MEMORANDUM

Re: 1410 South Huron St., Special Land Use/Preliminary Site Plan for True Credit Union

Preliminary Site Plan and Special Use Review For Ypsilanti Township, Michigan

Applicant:	True Community Credit Union (Represented by Heather Colonius)
Project Name:	True Community Credit Union Development and Drive-Through
Plan Date:	April 13, 2026
Latest Revision:	August 25, 2026
Location:	1410 S. Huron St. (On west side of S. Huron Street, just north of Culver's site) Note: The address of this site is 1410 S. Huron St. (per MapWashtenaw)
Zoning:	FB, Form Based District – Town Center; Site Type D
Action Requested:	Preliminary Site Plan and Special Use Approval

Figure 4. Front Setback Illustration

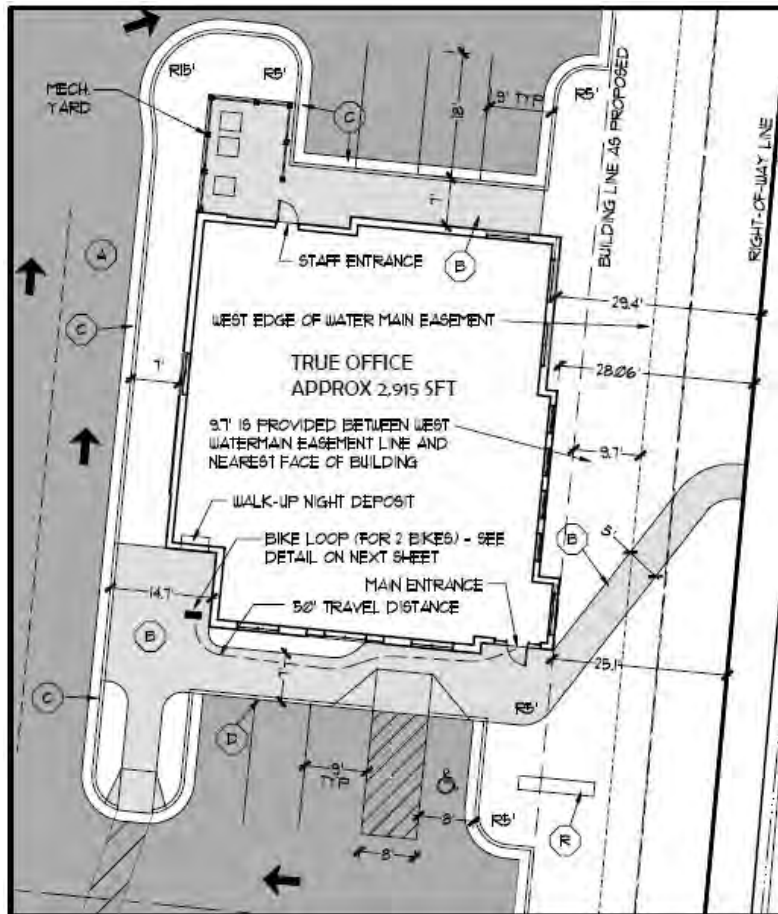
- The front façade of this building is stepped back from the front door. As requested, the setback dimension of the three sections of the front facade is shown on the plans (See Figure 4 below).
- The ordinance allows the Commissioners to adjust the “build-to” line up to a maximum of 30 feet if the project incorporates certain features, one being a cross-access drive with an adjacent parcel. This project offers a drive connection between Joe Hall, this site, and the Culver’s/Aldis to the south. We consider the project to meet the requirement for the build-to line adjustment to 30 feet.

- The form-based ordinance also requires that at least 75% of the building façade meets the required build-to-line, while up to 25% of the façade can be setback to allow for architectural considerations. The entire front façade meets the 30-foot build-to-line, if the Planning Commission agrees to this adjustment.

Items to be Addressed: 1) Planning Commission to evaluate building location up to 30-feet from Huron St. right-of-way, considering proposed cross access drive.

TURNING MAP

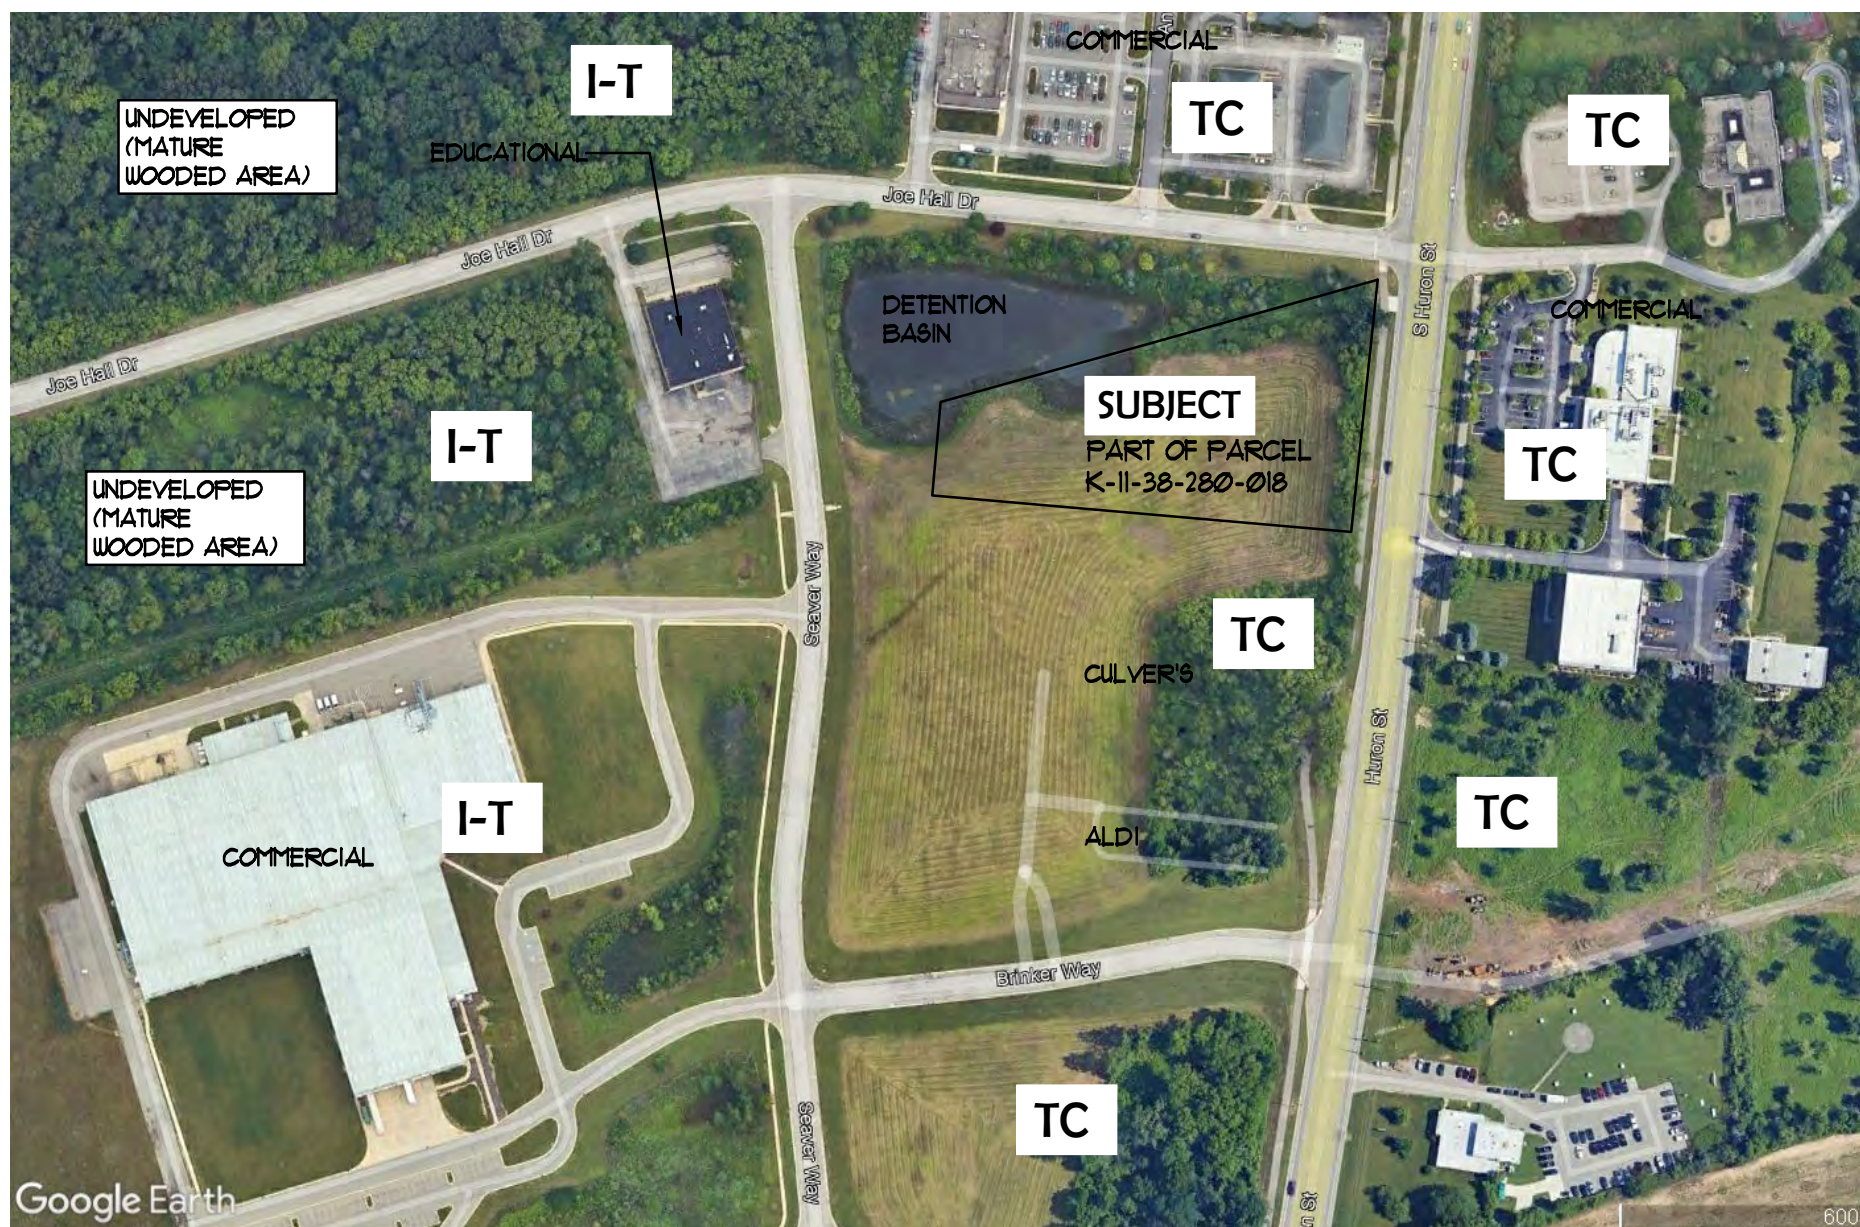
A "Turning Map" is provided on the Cover Sheet. It shows pavement dimensions of where a fire truck could traverse the site. We defer evaluation of the information provided to the Fire Marshall.

Items to be Addressed: 1) *Recommending Preliminary Site Plan approval, if granted, to be conditioned on the applicant providing a cross-access and maintenance Easement Agreement with Culver's and Aldis regarding internal driveway.* 2) *Defer evaluation of Turning Map information to Fire Marshall.*

1 TREE PROTECTION FENCE

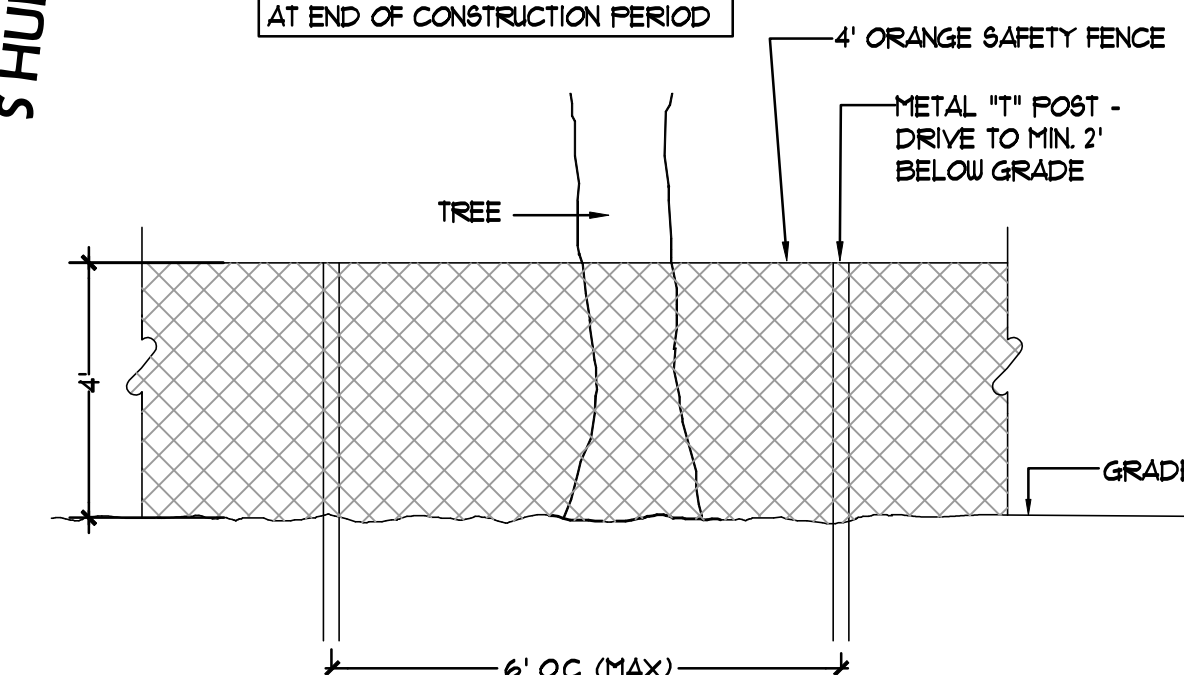
As requested, a Tree Protection Fence symbol is shown at the dripline of vegetation/trees to remain on the Site Plan and Grading Plan. Also, a Tree Protection Fence detail is provided. However, this detail should be amended to

indicate that the fencing is located at or further away from the dripline of the tree to be protected. This can be done at the Final Site Plan review stage. The Site Plan and Grading Plan also has a note stating the following:

Items to be Addressed: 1) Recommend that Preliminary Site Plan approval, if granted, be conditioned on the applicant providing a signed written Easement Agreement that reflects the preliminary agreement in the Letter of Intent. 2) Modify Tree Protection Fencing detail on plans to indicate fencing is installed at or further away from the dripline of the trees to be protected at Final Site Plan stage.

- 3) Conditioned on applicant addressing the following issues at the Final Site Plan stage:
 - a. Modify Tree Protection Fencing detail on plans to indicate fencing is installed at or further away from the dripline of the trees to be protected.

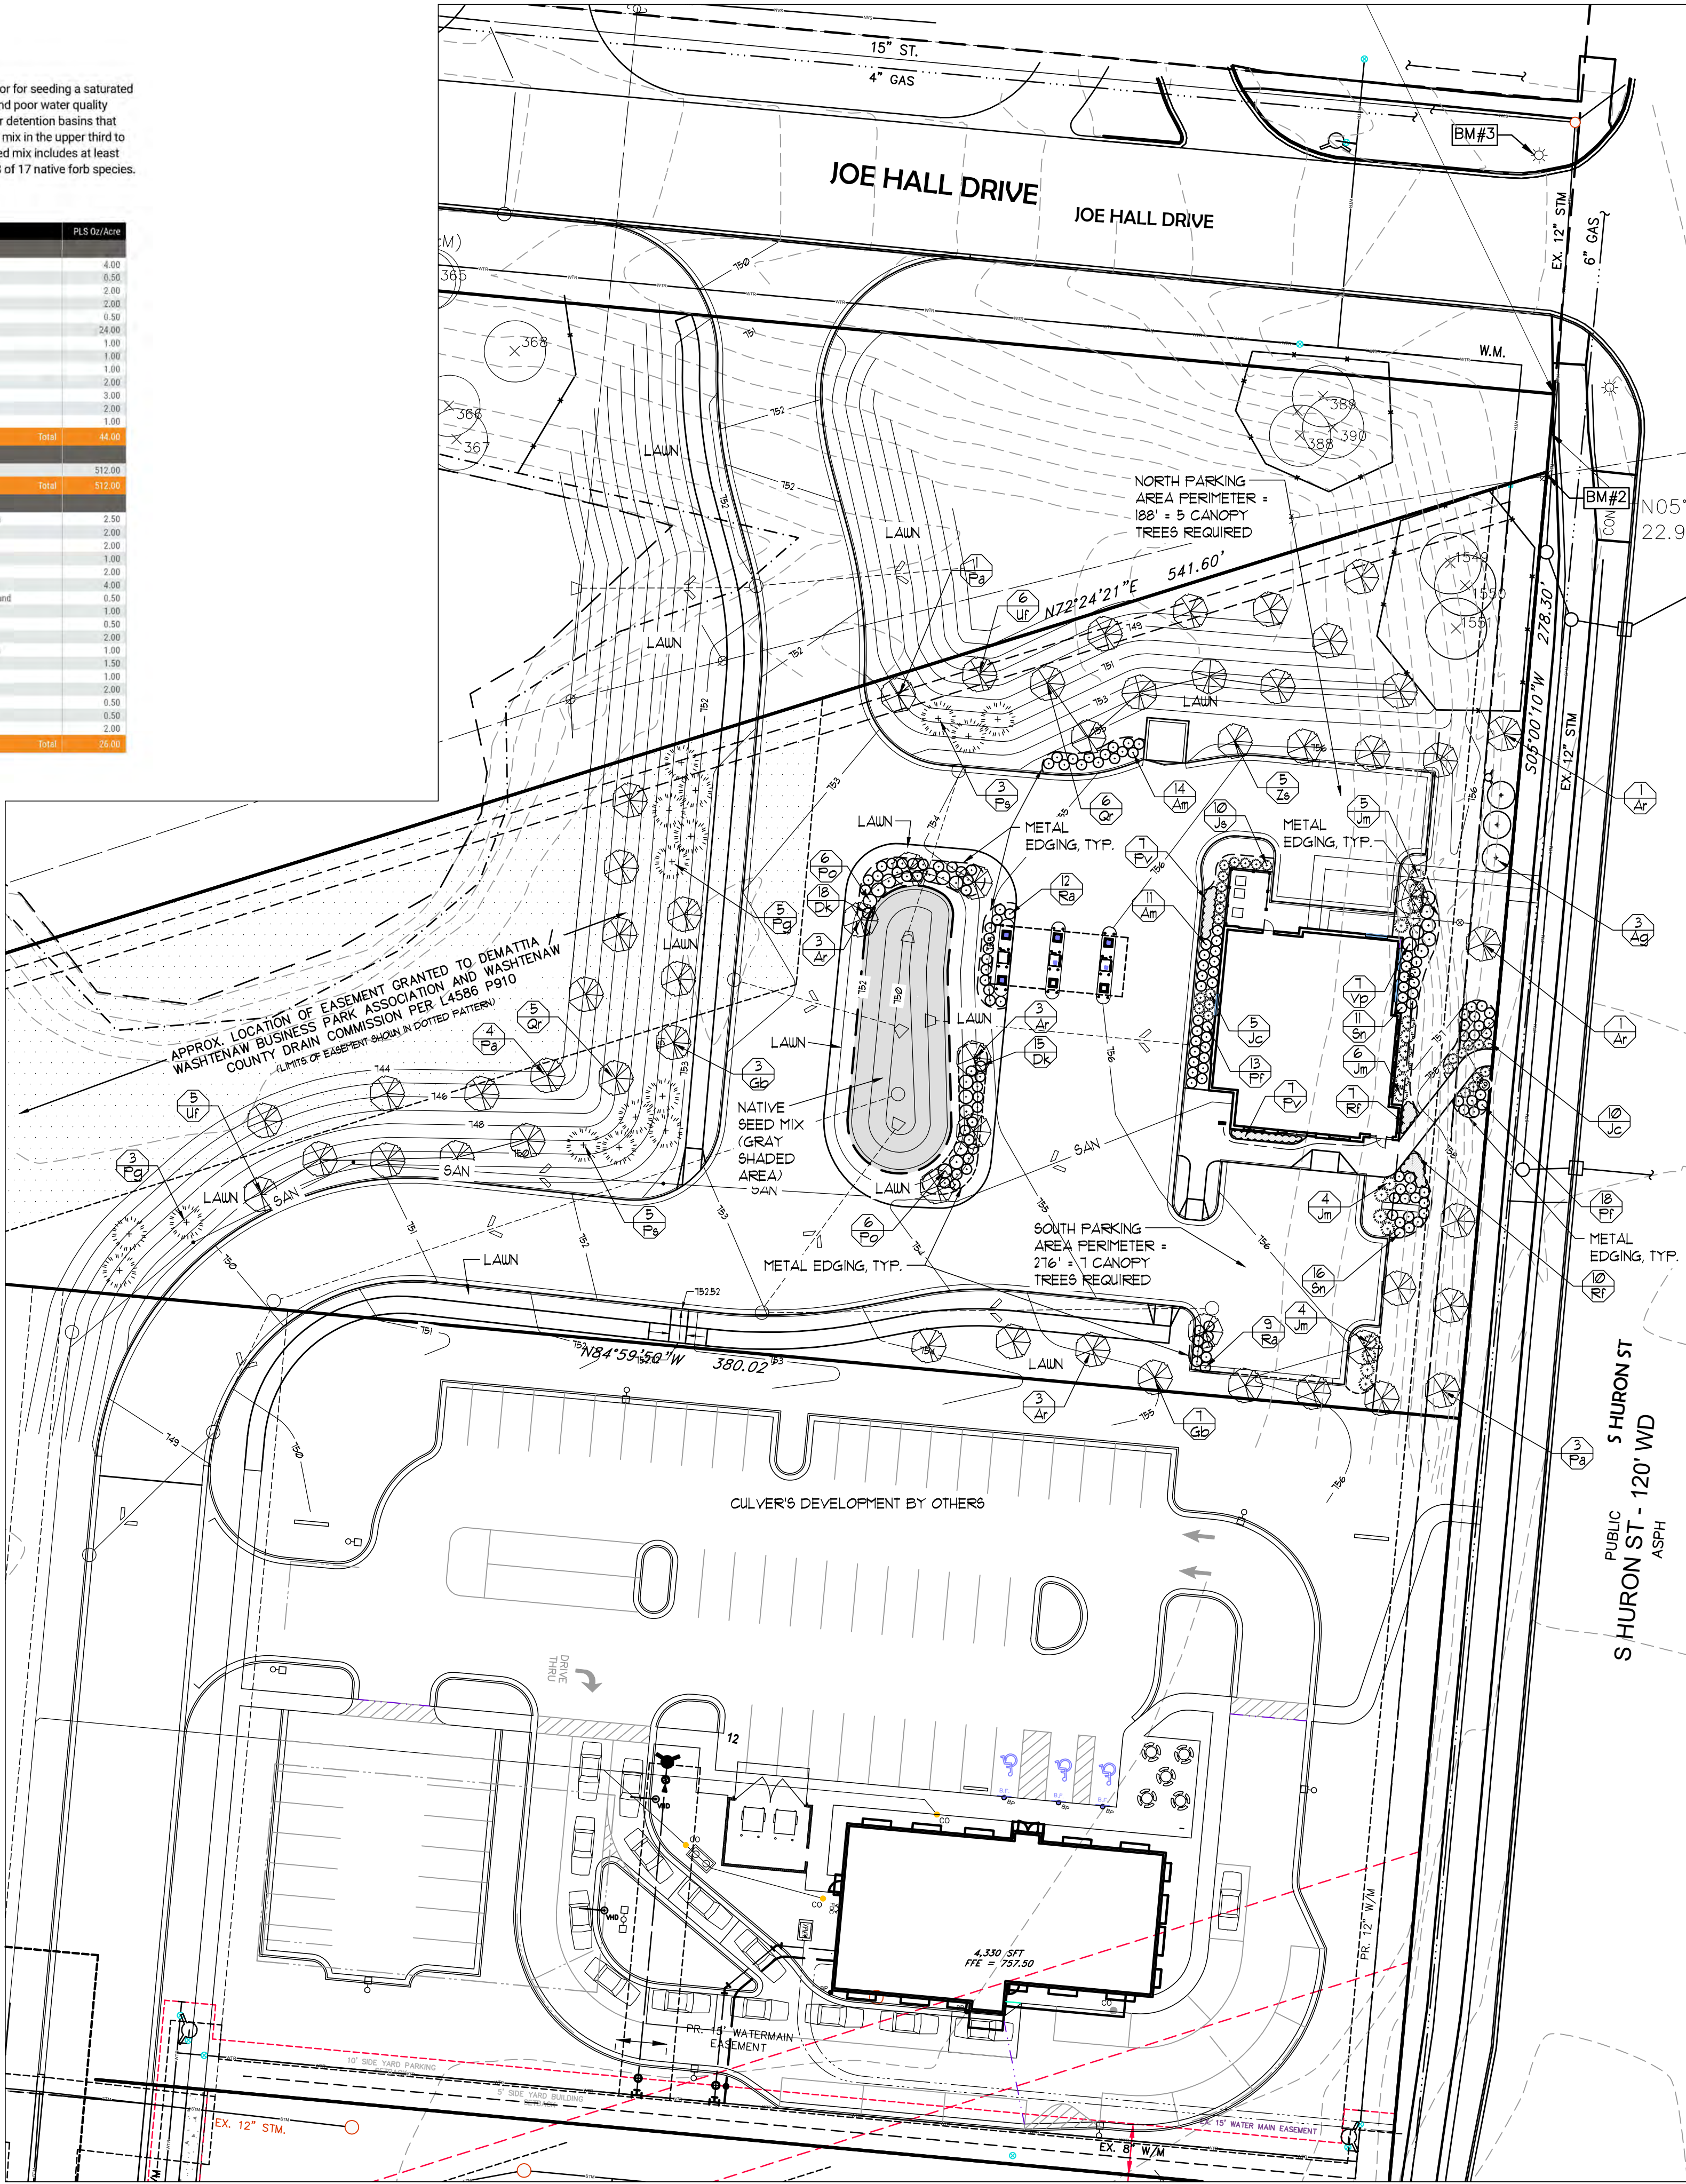
Quantities of each proposed plant species need to be added to the Landscape Plant List table on Sheet C6.0.

A. General Landscaping Requirements: The plans propose planting 57 new trees on their site. While the number of shrubs is slightly smaller than required, the plans show one additional tree (above the General Landscaping Requirements). The Planning Commission may consider alternative landscaping if the proposal meets the intent of the ordinance. In our view, the proposed landscaping is adequate, as it almost meets all requirements, and the one tree will perform some of the benefits that the 10 deficient shrubs would provide.

Items to be Addressed: 1) Add quantities of each proposed plant species to the Landscape Plant List table on Sheet C6.0. 2) Planning Commission to determine if landscape proposal meets the intent of the ordinance (considering one additional deciduous tree in lieu of 10 required shrubs).

- d. Add quantities of each proposed plant species to the Landscape Plant List table on Sheet C6.0.
 - e. Revise parking lot layout and building location on Sheets E010 and E011 to illustrate the most up-to-date site design.
